COUNCIL ASSESSMENT REPORT

SYDNEY SOUTH PLANNING PANEL

PANEL REFERENCE & DA NUMBER	PPSSSH-182 – DA-1182/2024
PROPOSAL	Redevelopment of the Compass Centre site including the demolition of all existing structures, tree removal, site preparation and early works, bulk excavation, remediation works, and construction of a mixed-use development comprising a 2-level basement and a 5-storey mixed-use podium with 3 towers above, including a 19-storey hotel tower and 2 x 24-storey residential towers.
ADDRESS	Lot 19 and 20, DP 5541 Lot 18B, DP 412699 Lot 15, 16, 17, 21, 22, 23, 24, and 27, DP 5541 Lot 1, DP 507818 Lot 1, DP 207810 83, 85 and 99 North Terrace, Bankstown
APPLICANT	Altis Bulky Retail Pty Limited
OWNER	The Trust Company (Australia) Limited
DA LODGEMENT DATE	22 October 2024
APPLICATION TYPE	Integrated Development Application
REGIONALLY SIGNIFICANT CRITERIA	Section 2.19(1) and Clause 6 of Schedule 6 of <i>State Environmental Planning Policy (Planning Systems) 2021</i> declares the proposal regionally significant development as the proposal is for development that has an estimated development cost of more than \$30 million.

Figure 11: Site Image (Source: Updated Landscape Design Report, Site Image)

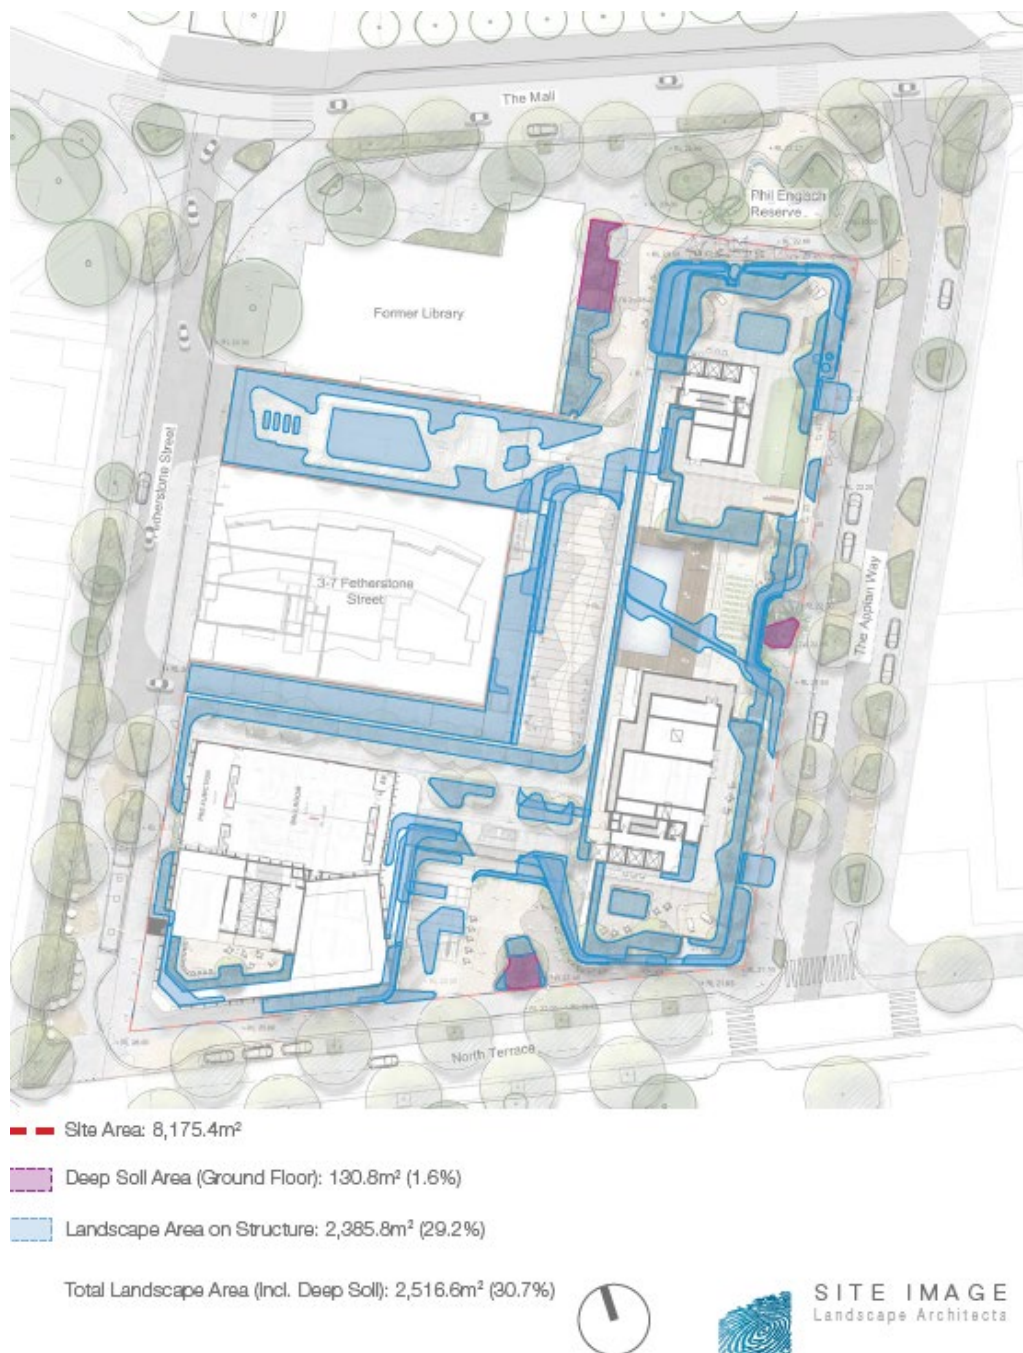
The lack of deep soil was raised in an RFI and in response, an updated Landscape Design Report and supporting landscape plans were submitted demonstrating the extent of on-structure planting to supplement the deep soil areas at ground level. The updated Landscape Design Report also identifies that the Design Guidance associated with Objective 3E-1 acknowledges that achievement of the required deep soil area may not be possible for sites within urban settings including central business districts.

This could be achieved with enlarged or additional deep soil plantings/nodes along edges of the site, particularly along The Appian Way and/or Fetherstone Street frontage to maximise plantings, specifically canopy trees. Additional plantings at the ground plane may also contribute to the enhancement of the public domain, in line with the Bankstown Complete Streets Transport and Place Plan, under which the southern end of Fetherstone Street is to be converted to a pedestrian-only thoroughfare, and the northern end is to become a shared zone. The Plan also identifies the conversion of The Appian Way into a shared zone and the main “activity spine” of the Bankstown City Centre.

Figure 11a: Northern setbacks of Building C to Phil Engisch Reserve (Source: Drawing B1L0610, PTW Architects)

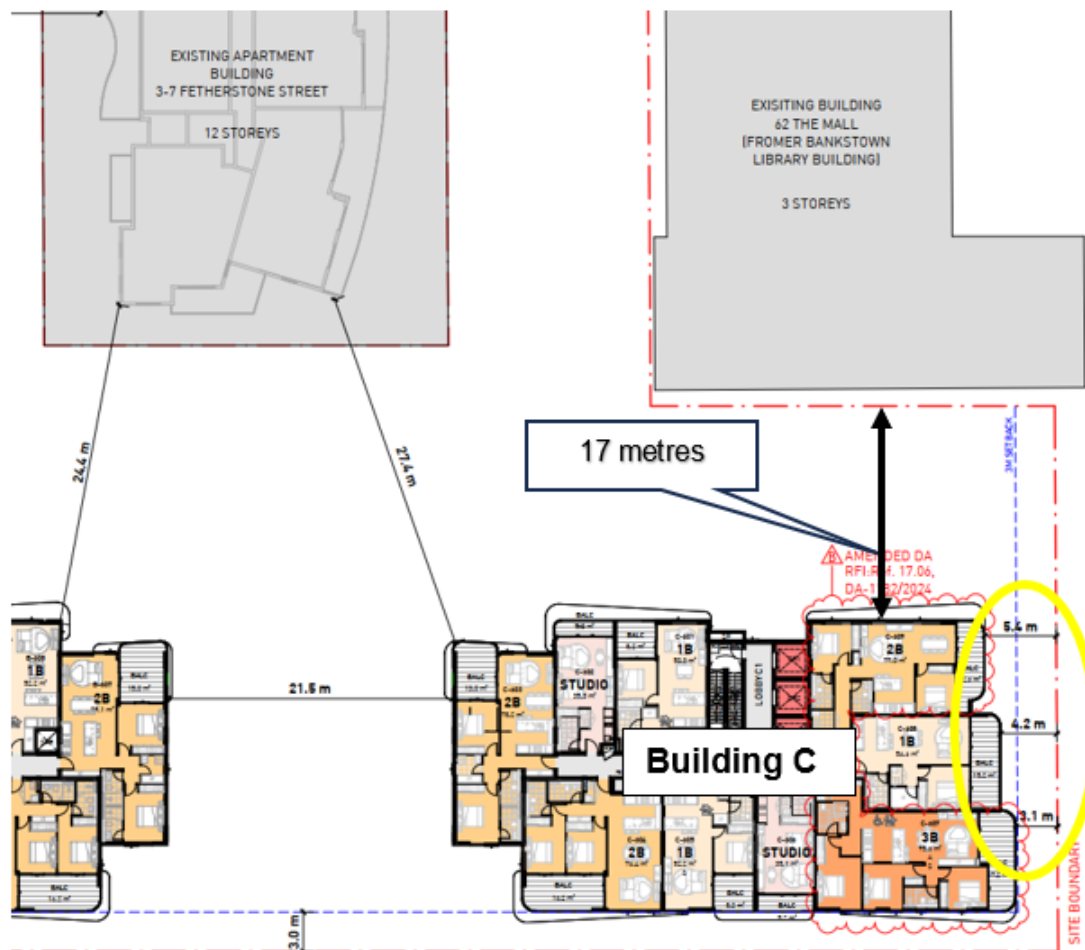
The proposed setback distances of the upper residential levels of Building C to the eastern extent of the northern boundary, shared with 62 The Mall/Phil Engisch Reserve, range between 3.1 and 5.4 metres. Therefore the proposal does not satisfy the relevant design criteria under Objective 3F-1 which requires setback distances to the northern boundary ranging between 9 metres and 12 metres for the tower levels.

The (Building C) tower setbacks to the northern boundary are circled in yellow in Figure 11a below.

Achieving strict adherence of the design criteria by increasing the northern tower setbacks of Building C would have no material benefit for the redevelopment of the eastern portion of 62 The Mall, occupied by Phil Engisch Reserve. If the equivalent ADG compliant setbacks were

Figure 12a: Extract of solar access diagram – Level 6 to 23 (Source: Drawing Q110060, PTW Architects)

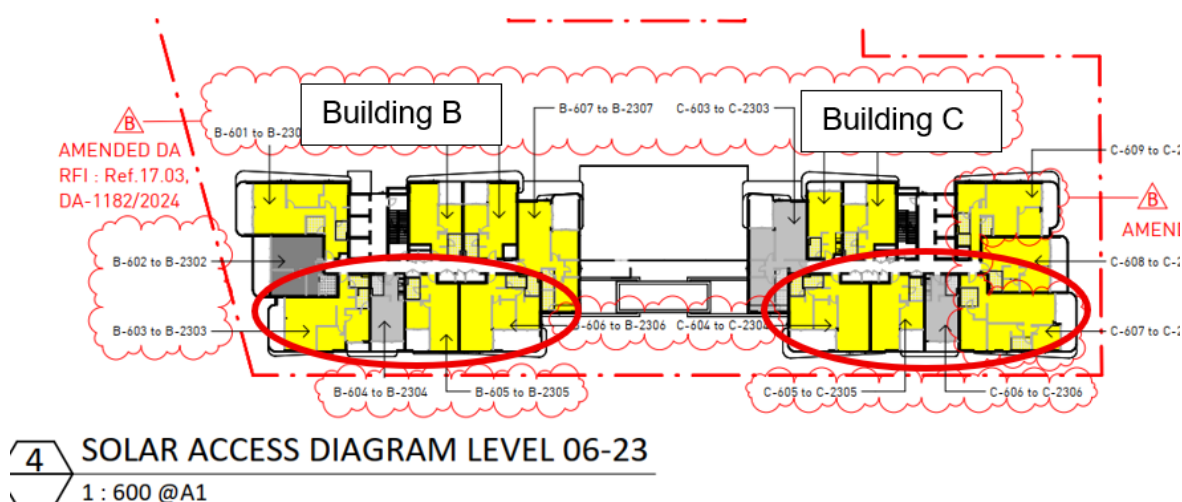
The architectural plans do not demonstrate that the living rooms and private open spaces of at least 70% of the proposed apartments receive a minimum of 2 hours of sunlight between 9am and 3pm in accordance with Design Criteria 1 in Objective 4A-1. For example:

- The solar access diagrams for Level 6 to 23 included in the architectural plans (Drawing Q110060) indicate that all east facing 1, 2 and 3-bedroom apartments in Building B and Building C receive more than 2 hours of direct sunlight. This is contrary to the sun-eye view diagrams which demonstrate that these apartments receive direct sunlight between 9am and 10am only (Drawing Q110030-31). The diagrams do not demonstrate that solar access is provided to the living rooms of these apartments after 10am. Extracts of the solar access diagram and sun eye-view diagrams at 9am, 10am and 11am are included at Figures 12a to 14 below. The east facing apartments are marked in red.
- Solar access to the private open space areas of apartments is not identified on the solar access diagrams (Drawing Q110060) or the ADG Compliance Assessment in Section 10 of the updated Architectural Design Report.

Figure 15: Extract of cross ventilation diagram – Level 6-8 (Source: Drawing Q110061, PTW Architects)

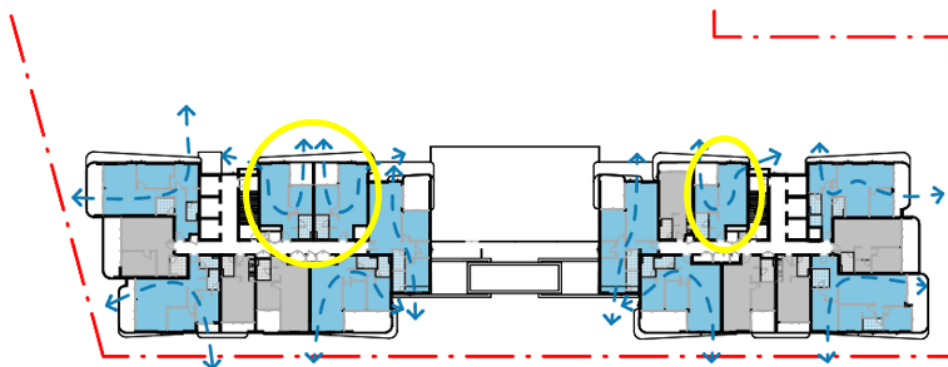
An extract of the ventilation diagram for Levels 6 to 8 is included in Figure 15 below. The diagram identifies that Units B608 B609, B708, B709, B808, B809, B908 and B909 in Building B, as well as unit C601, 701, 801 and C901 in Building C are ventilated. The locations of these apartments are circled yellow in Figure 15.

However, these units are not cross ventilated as they include outlet windows which are significantly smaller in area than the respective inlet openings, as illustrated in the respective typical unit layout (Drawing B1TYP12) in Figure 16 below (outlet window circled yellow). Furthermore, the actual size and details of the windows have not been provided (i.e., relevant sections and elevations).

Figure 19: Flood impact assessment (Source: Canterbury-Bankstown Council)

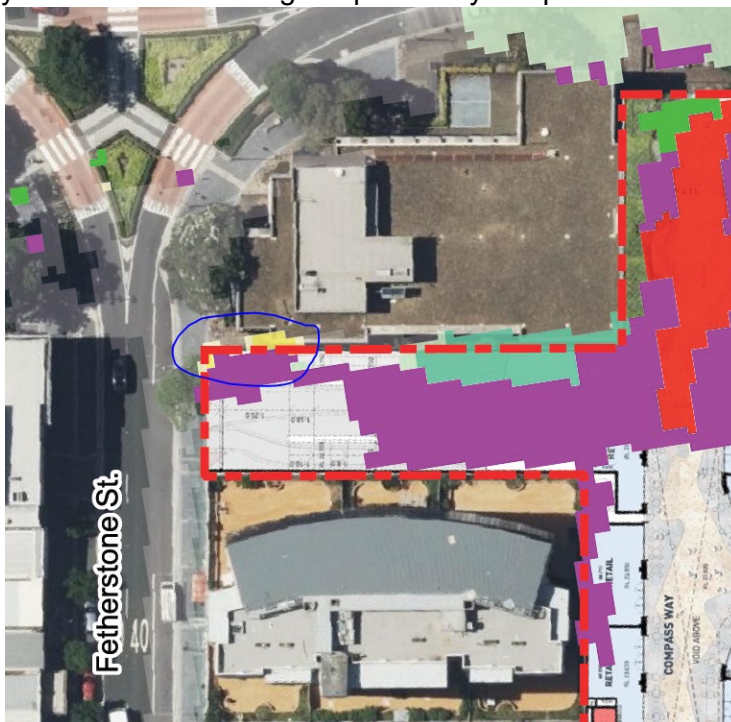
- The Flooding Engineering Statement does not provide details of flood mitigation measures that will be implemented to manage flood impacts associated with the obstruction and diversion of the overland flow path traversing the site. The connectivity of the existing overland flow path from Featherstone Street to Appian Way via the present day car park (which generally follows the alignment of the existing easements) will be lost once the easements are extinguished and the retail and loading car park entry ramp are constructed. Despite mention of flood mitigation measures to be proposed as part of the development - including on-site flood storage and stormwater upgrades, no details have been provided either in the reports or plans to demonstrate that these measures will be introduced.

- Any off-site flood impacts up to the 1% AEP event including any localised increase in flood level on the former Council library will need to be addressed. The flood impacts indicated below in Figure 19 are a result of blockage of the existing overland flow path by the retail and loading car park entry ramp as discussed in Point 3 above.

- The inflow hydrographs for the Sydney Water culverts on Appian Way should be incorporated to account for sub-surface flows in addition to the overland flows provided by Council.
- The proposed threshold level of the development shown below does not meet Council's DCP requirements:

Figure 21: Extract of Figure 2 in written request (Source: Figure 2, Written Request, Ethos Urban)

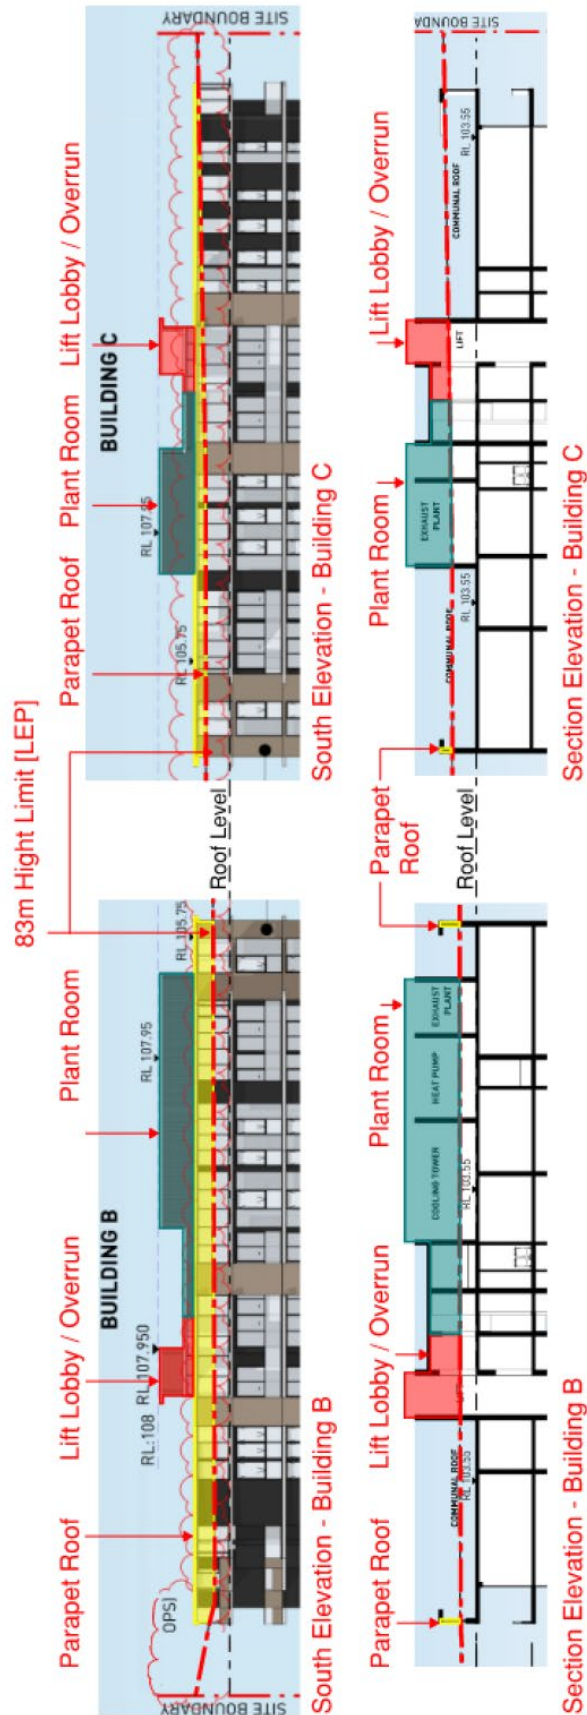
- The “South Elevation” extracts included at Figure 2 of the written request are inconsistent with the southern elevations included in the set of architectural plans. The extracts in Figure 2 appear to reflect the eastern elevations of each building.

- The written request argues that the components that exceed the height limit exclude habitable space which appears to be inconsistent with the elevation drawing extracts provided in the document. Figure 2 of the written request includes elevations which identify window openings and balcony areas exceeding the height limit. For this reason, the external façade design of the uppermost level of Building B and Building C (i.e., rooftop/Level 24) requires clarification. Extracts of the elevations presented in the written request are included in Figure 21 below.

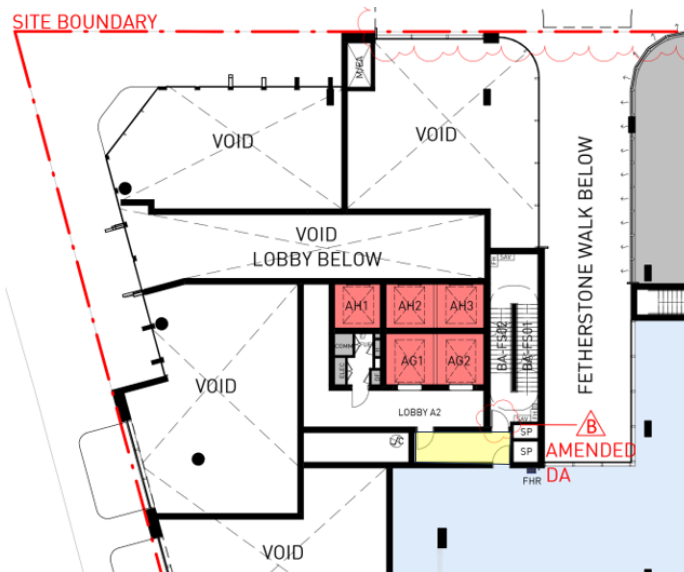
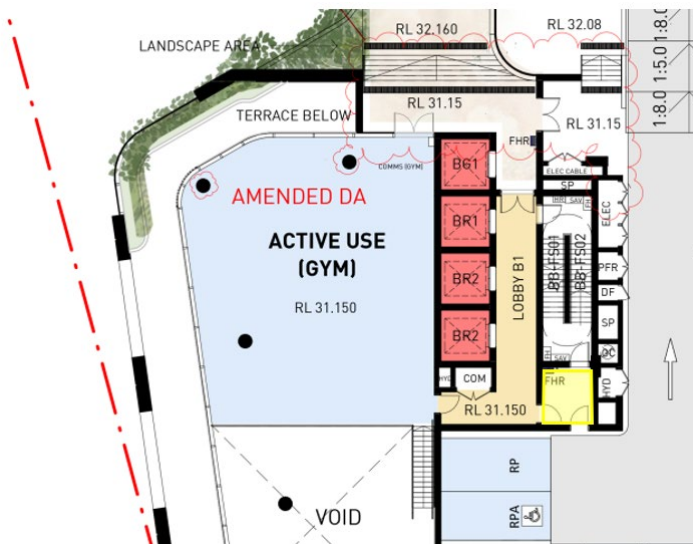
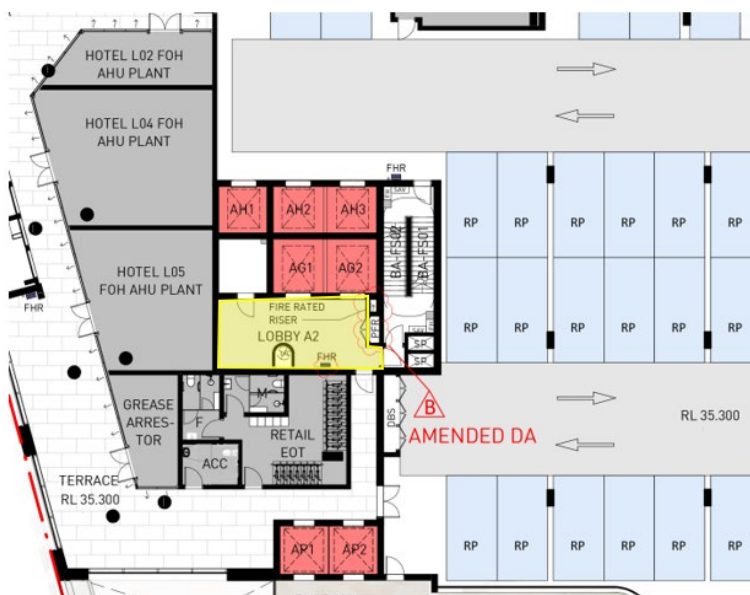
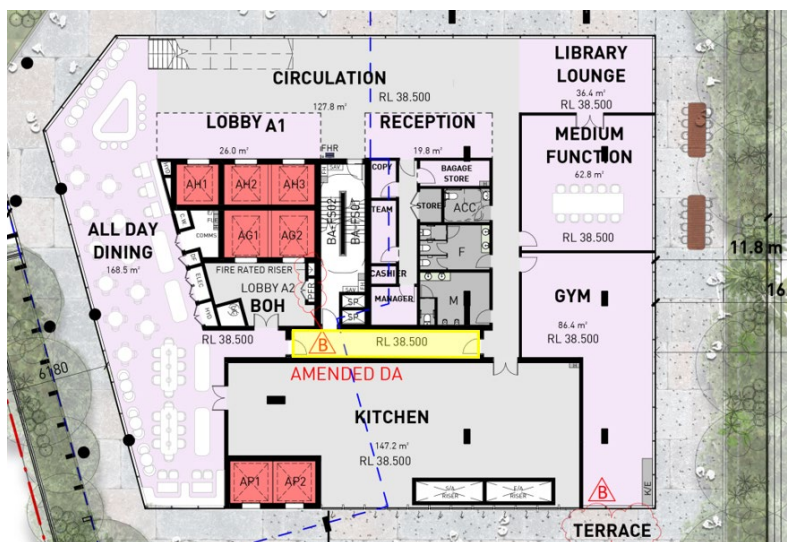
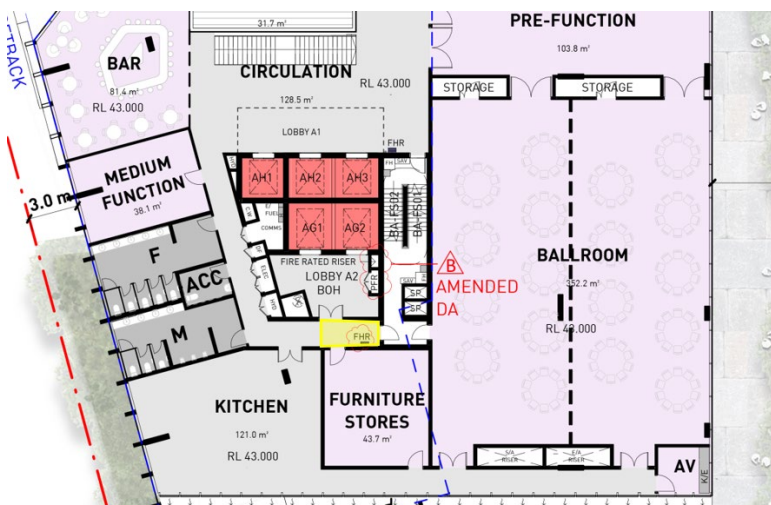
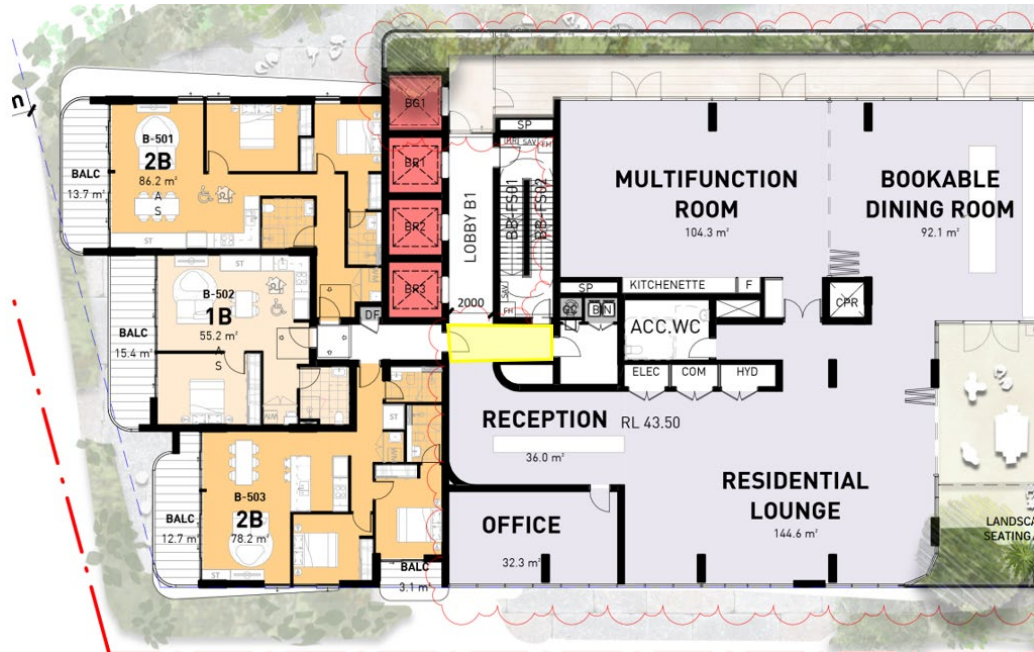
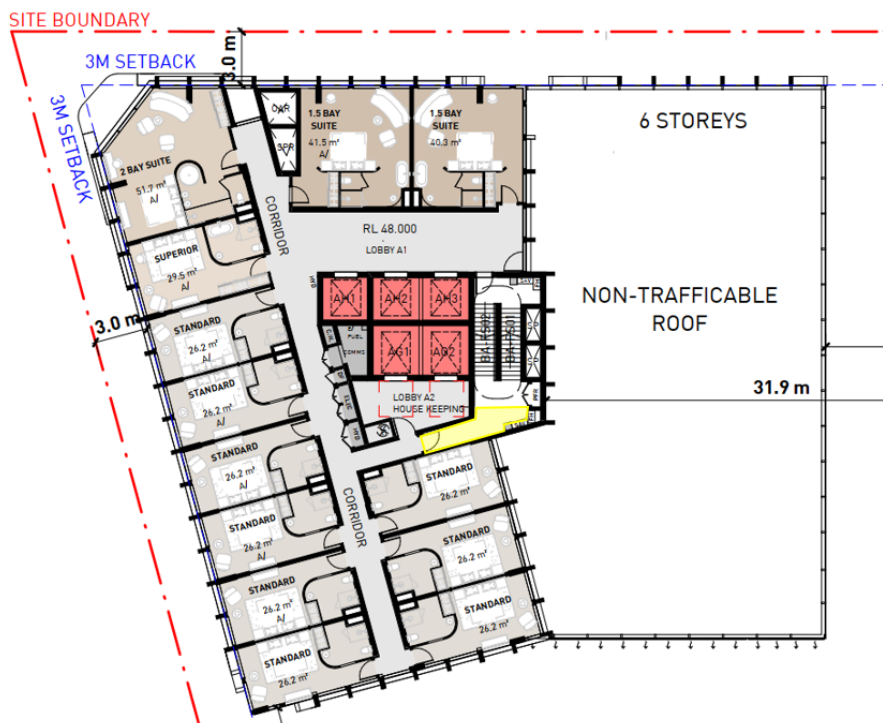
The areas identified above are circled or marked in yellow in Figures A to K below.

The areas identified in Figures A to K above constitute GFA in accordance with the GFA definition and occupy a combined total area of 170m².
